### Product Information Bulletin

**Number:** 9237  
**Date:** 10/28/2015  
**Division:** Wayne Dalton  
**Product Family:** Traditional Steel and Commercial Insulated  
**Product Series:** 8300/8500 and 5100/5150  
**Topic:** Update for 18' Door Embossment Spacing

**To:** All Wayne Dalton Dealers  
**From:** Mark Sawicki  
**RE:** Update in 8300/5100 & 8500/5150 18' Door Embossment Spacing

Figure 1: Label on Packaging for Identifying New Embossment Spacing

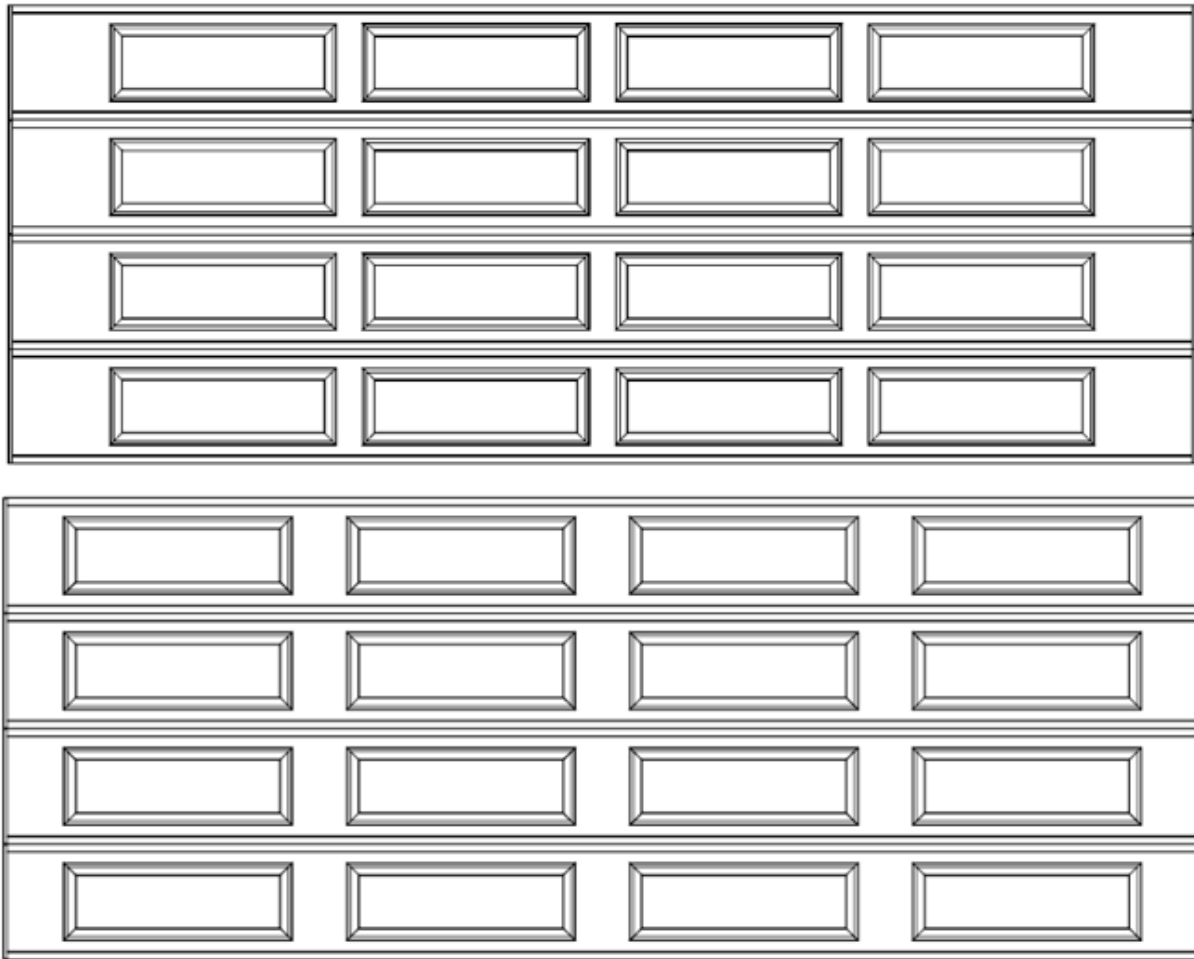
Effective November 16, we will be producing the Models 8300/5100 & 8500/5150 Ranch 18' wide door with visually improved spacing. The end spacing will decrease from 18.3" to 10.875" and the spacing between embossments will increase from 4.75" to 9.75" for a resulting look that distributes the embossments more evenly along the opening. Additionally, this change will better accommodate wider decorative hardware placed in between the embossments, similar to the spacing for the Sonoma Ranch. Widths other than 18' will be unaffected by this change.
